Plant Name: Seabrook Station, Unit 1
Docket Number: 50-443
Resp. Directorate: PWR Directorate #5
Project Manager: Victor Nerses
Review Branch: Facilities Operations Branch, DPL-A
Review Status: Ongoing

SEABROOK STATION STEAM GENERATOR TUBE RESPONSE

This report addresses the state of knowledge pertaining to Steam Generator Tube Rupture during postulated severe accidents (approach to core melt and core melt), and the application of this knowledge to the Seabrook Station nuclear power plant. This is an interim report, prepared with the assumption that the work and assessment will continue. The report does not cover all material received from Public Service of New Hampshire (PSNH) and its contractors, nor is it intended to provide a complete coverage of the issue. It does, however, identify a number of areas where work has been accomplished, it provides an assessment of that work, and it provides suggestions for future work which may be needed to resolve the issue. Actual resolution effort will depend upon addressing such issues as a pressurized Reactor Coolant System vs. one which has been depressurized.

Figure 1

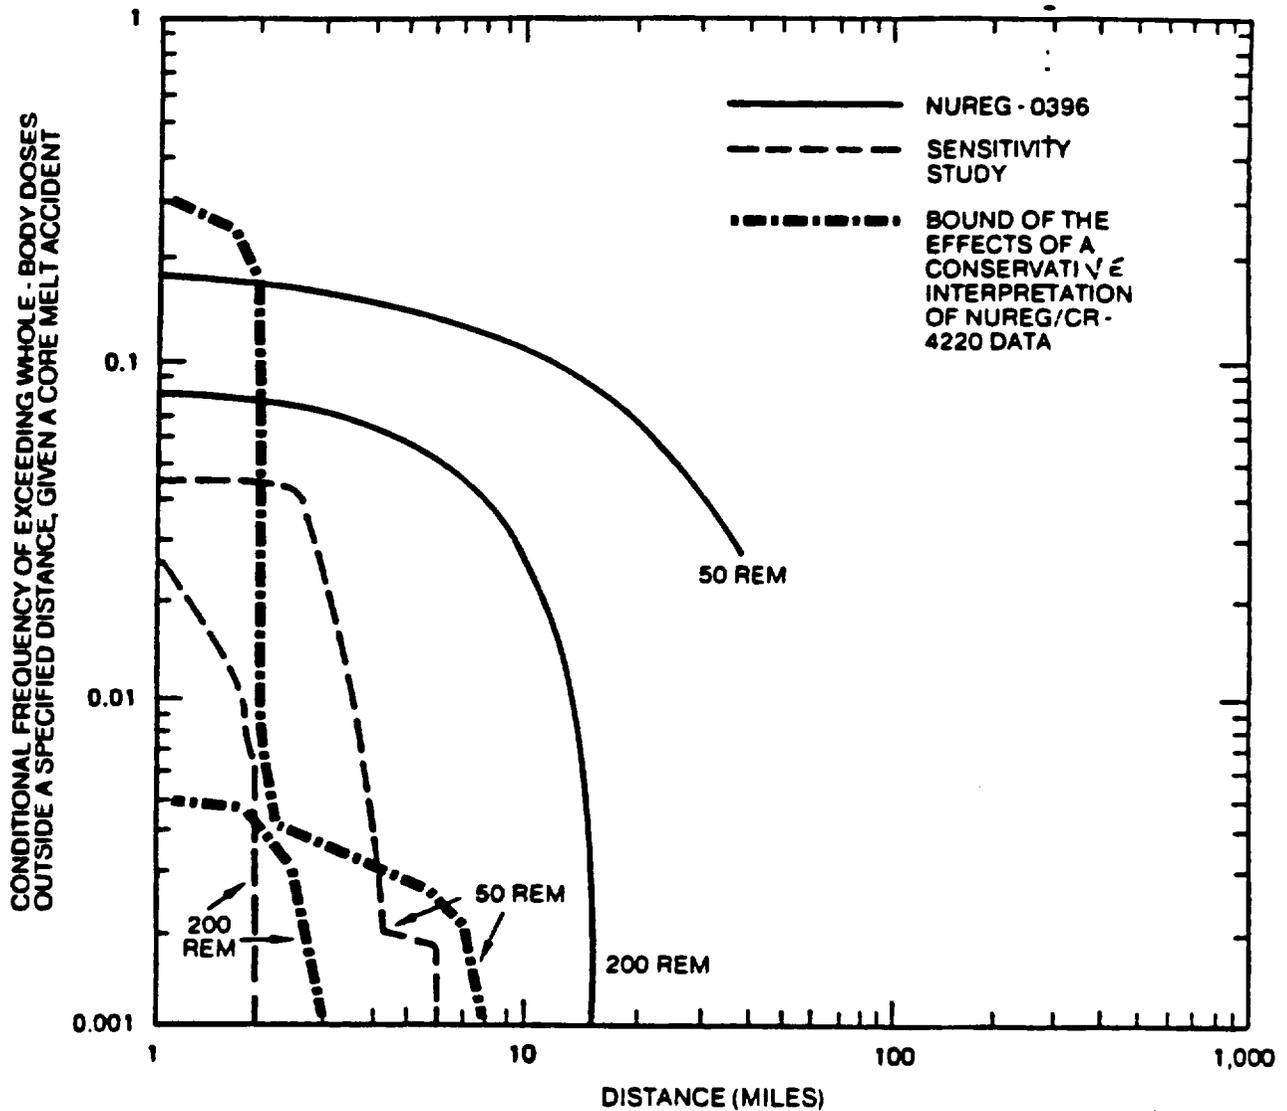
- Conclusion: Based on its review of the information available the staff concludes that the purge and vent valves in a fully closed configuration should provide reliable isolation of the Seabrook containment under severe accident conditions up to the pressures corresponding to 1% hoop strain in the containment.

The staff also concludes that the applicant has presented a reasonable approach for the consideration of preexisting leaks, both small and large.
